SUBJECT: VILLA SAN JUAN

AMMENDED STAFF REPORT 4/7/82  
ARCHITECTURAL REVIEW BOARD

PROPOSAL: 218 New Housing Units, ARB Review of Exterior Elevations

NEW REVISED  
DRAWINGS

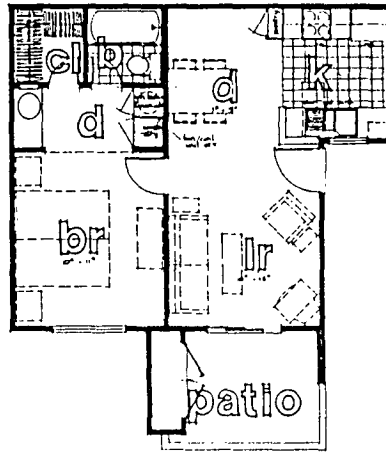
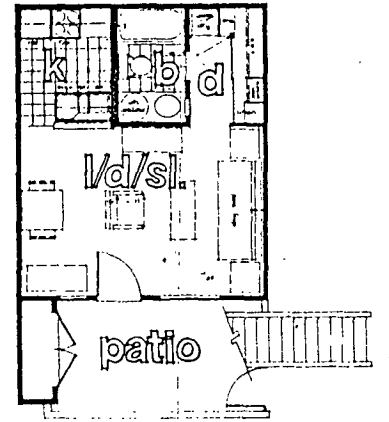
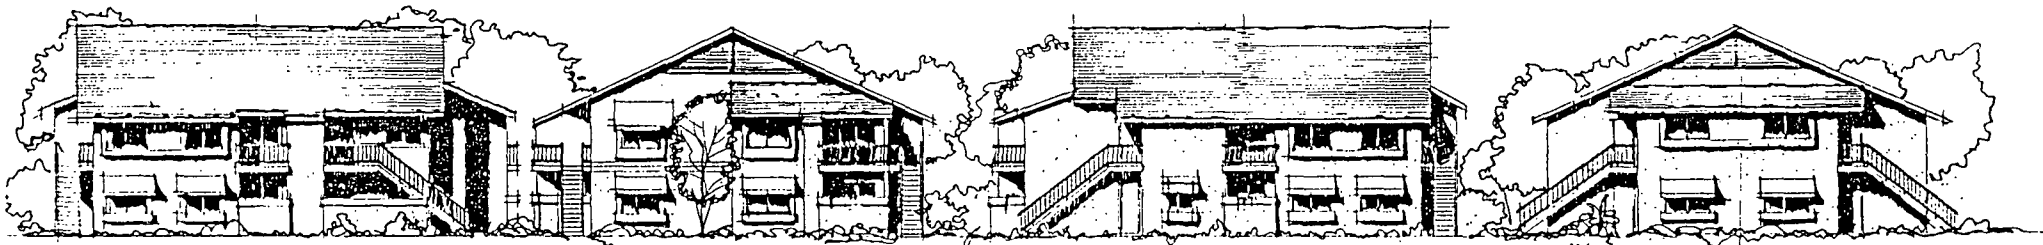
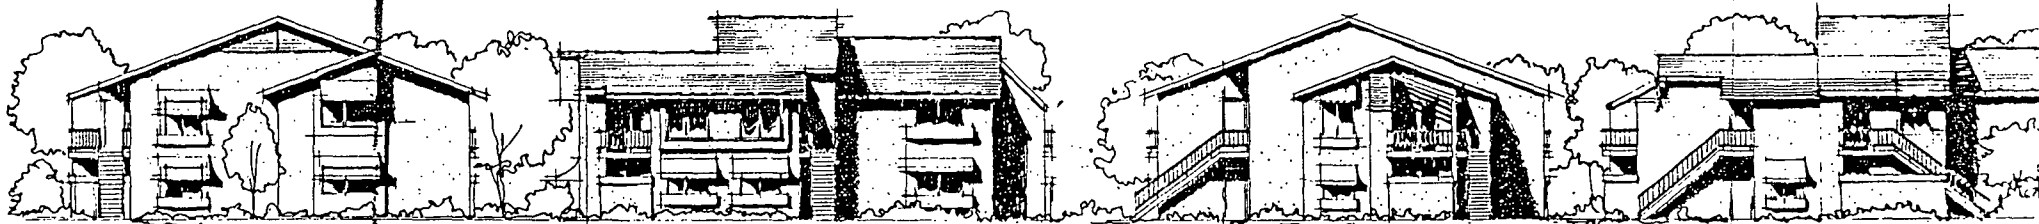
This project was approved with conditions. See attached staff report. The applicant has returned with elevations which do not match the conditions placed on the project as approved by the Board, but in staff's estimation will provide a better looking complex.

1. Staff feels that a change in wall treatment would be appropriate on those elevations where no window or door openings are proposed. Staff feels that a horizontal siding painted the same color as the stucco would be appropriate. This would allow a change of texture and yet keep the color scheme the same. Horizontal siding should not be any more expensive than stucco.

2. Staff feels that a portion of each of the deck areas railings should be in solid material. This would serve as a screening devise to hide miscellaneous patio items which are usually stored outdoors. This would provide an attractive alternative to the usual visual blight that is found on these type of deck areas.

3. Staff feels that each deck area should have some type of overhead cover. Either as part of the permanent construction of the building or in the form of canvas awning. Many of the decks as proposed do have a cover provided. All ground level decks are covered over by the deck of the second floor patio. Only some second floor patios are not provided with a covering devise. Staff feels that is important for a feeling of enclosure to provide some overhead protection from the sun and rain and to give an indication of some privacy.

4. Staff feels that the decks could further provide a sense of enclosure and privacy in those areas where the deck is only adjacent to one wall of the structure. Staff feels that a wing wall extending out from the face of the building and running up the width of the deck from ground to roof line would provide, not only a sense of enclosure for the deck areas, but also would provide a design element on the exterior of the building.

Staff recommends approval of the project with the revised drawings. This would require modification of Condition No. 2 to read ...open lattice or roof; Condition No. 3 should be deleted; and Condition No.4 should be deleted.

1. ~~The applicant will provide horizontal siding painted the same color as the stucco on the walls of the structures which do not have window or door openings.~~
2. The applicant will provide overhead ~~roofing or awning~~ *lattice and open lattice* over all deck areas.
3. The applicant will provide ~~some solid railing areas on each deck to be used as screening in order to hide stored items from public view.~~ *behind a portion of each deck railing.*

4. The applicant will provide a vertical ~~wing~~ wall extending out from the surface of the building adjacent to each deck where that deck is now only adjacent to one wall surface of a building.
5. Final irrigation and landscaping plans will be returned to staff for review and approval.

- \*\*6. *Applicant will redesign the type of texture to be used on blank wall surface. Treatment at the discretion of the architect.*
7. *Revised color board to be resubmitted to the Board for review and approval.*
8. *Landscaping and irrigation plan resubmitted to the Board for review and approval.*
